P.O.A.D.P. PLAN
 for
 INTERCHANGE PARK

Re: Interchange Park

POADP # 583

The City Staff Development Review Committee has reviewed Interchange Park Subdivision Preliminary Overall Area Development Plan # 583. Please find enclosed a signed copy for your files. Although your plan was accepted, please note the following:

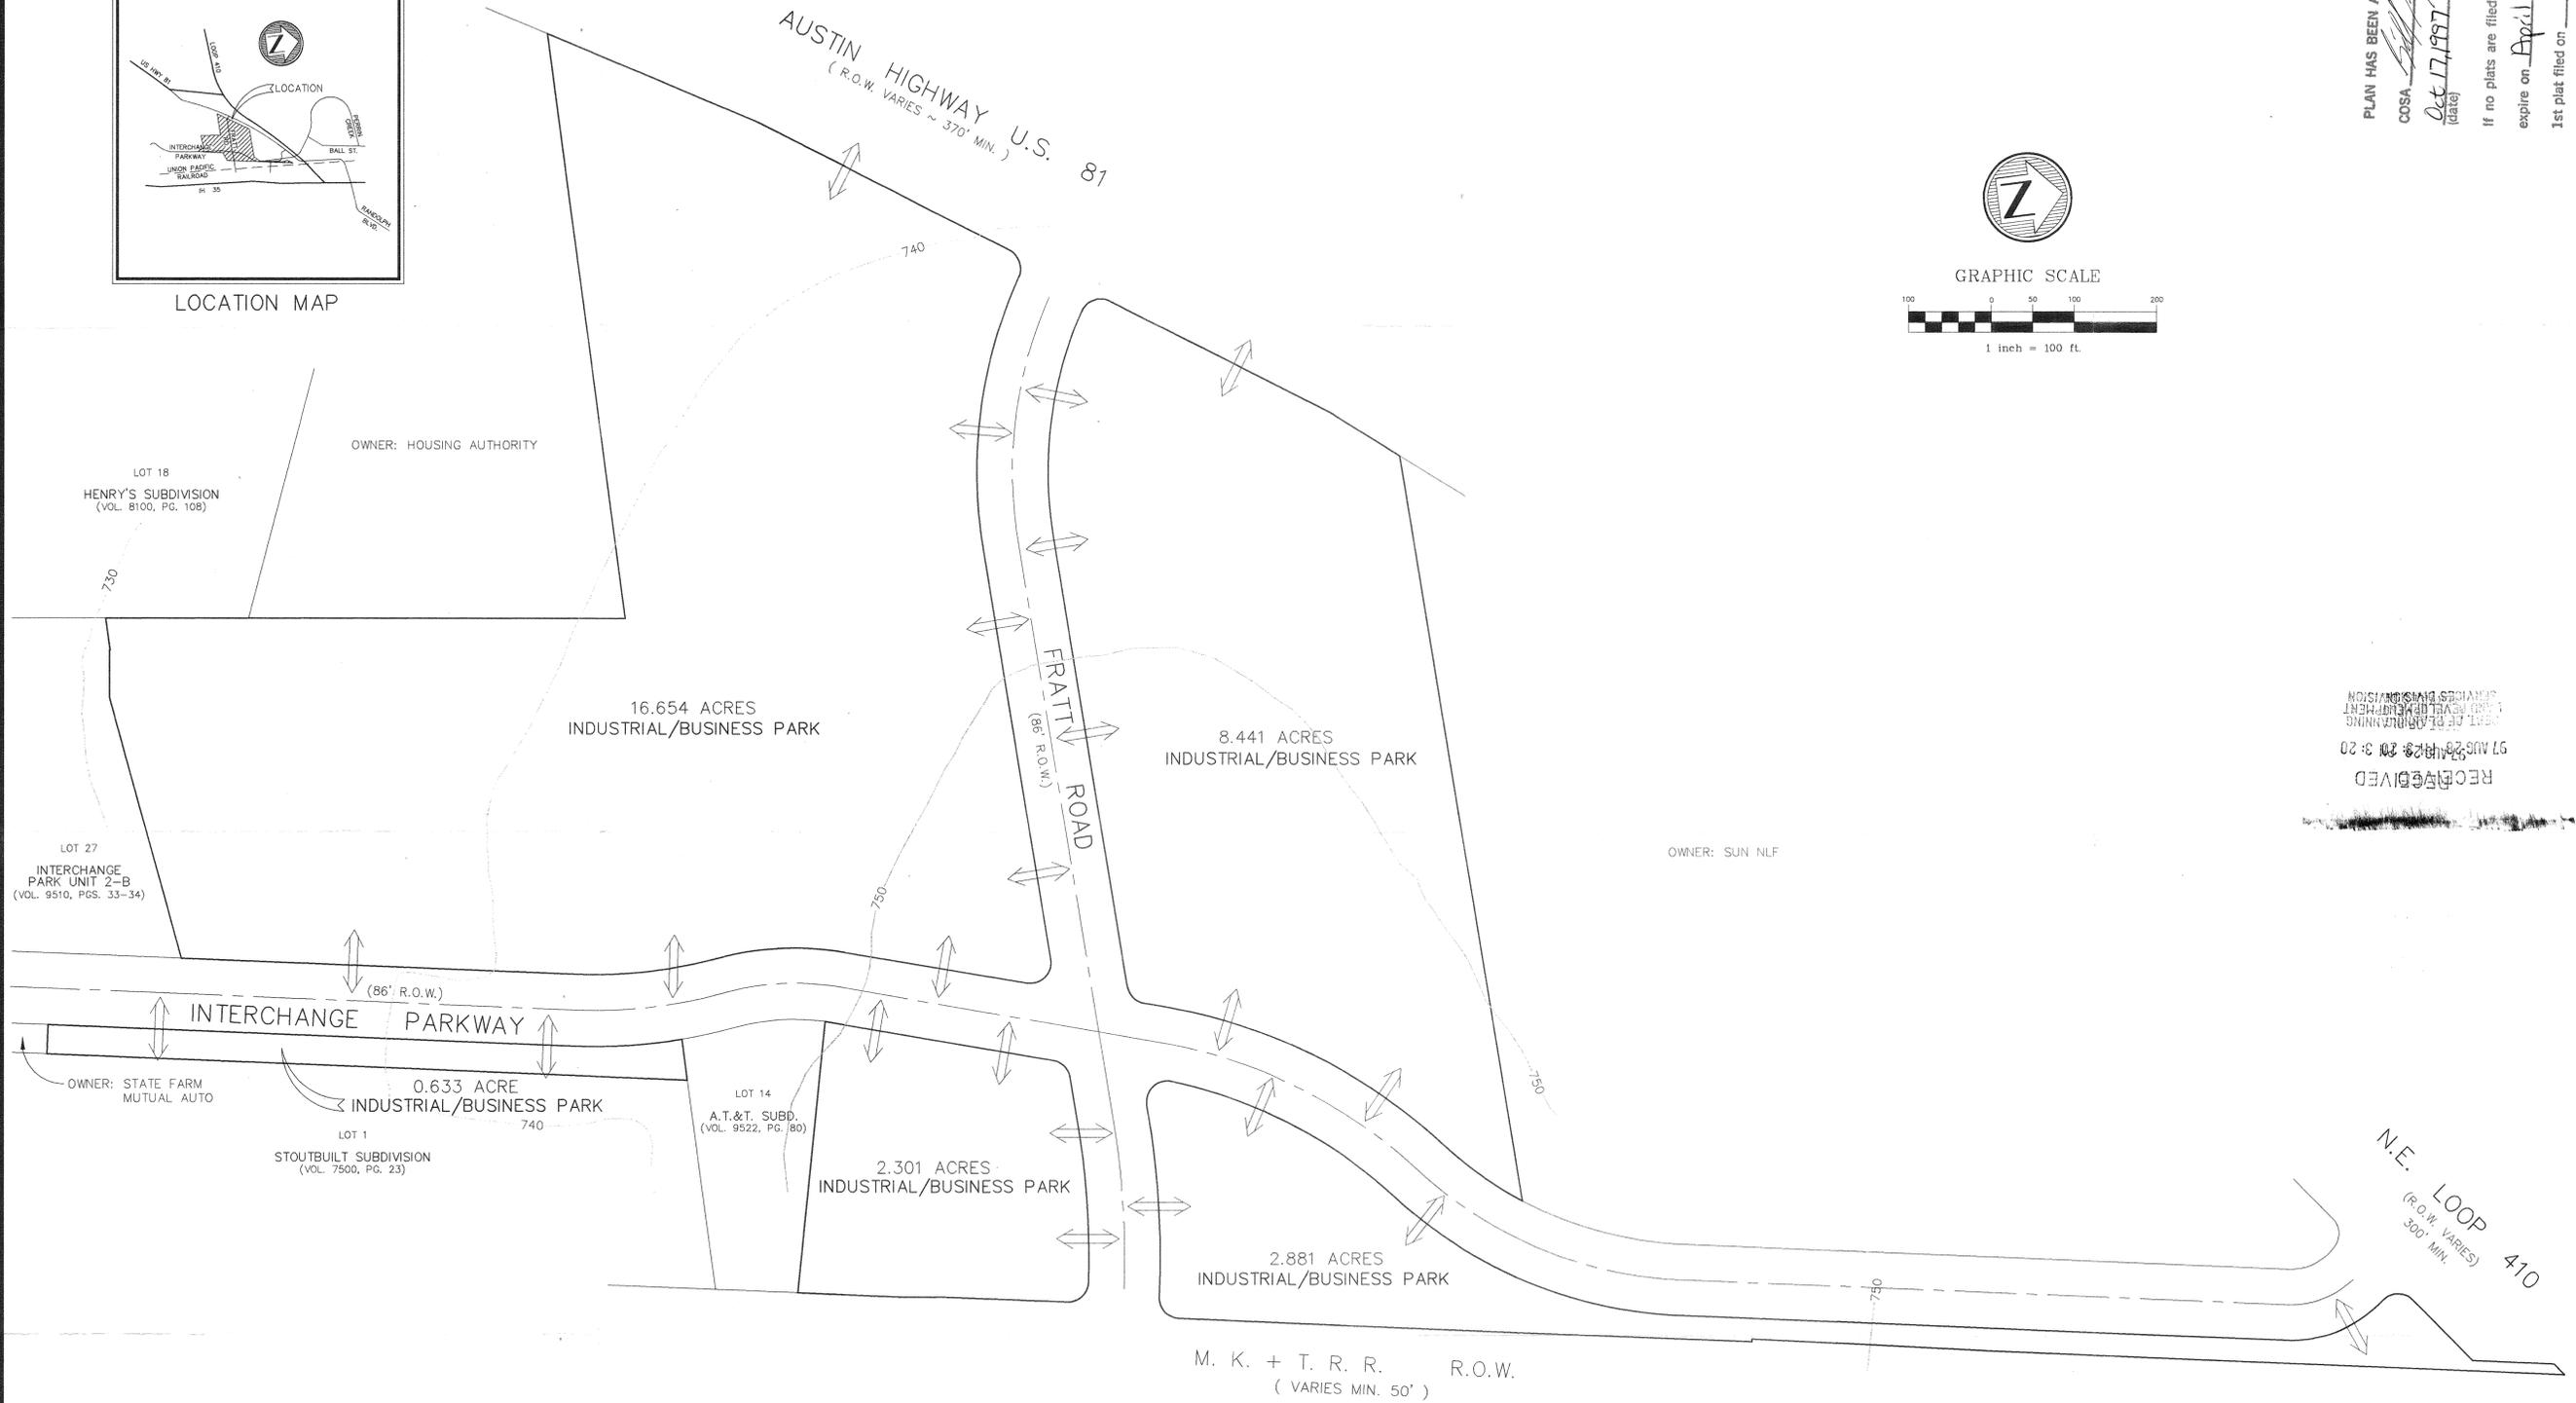
- Access and R.O.W. issues along State facilities will need to be resolved with the Texas Department of Transportation (TXDOT). For additional information about these requirements you can contact TXDOT at 615-5814.
- Based on the topography, a Flood Plain Study and drainage review will probably be required during the platting process.
- This development will need to comply with tree preservation ordinance #85262. For additional information about these requirements you can contact Building Inspections at 207-7102.

Please note that this action by the committee does not establish any commitment for the provision of utilities, services or zoning of any type now or in the future by the City of San Antonio. If the proposed development is not platted in phases this POADP will be invalid. Platting will have to comply with the UDC.
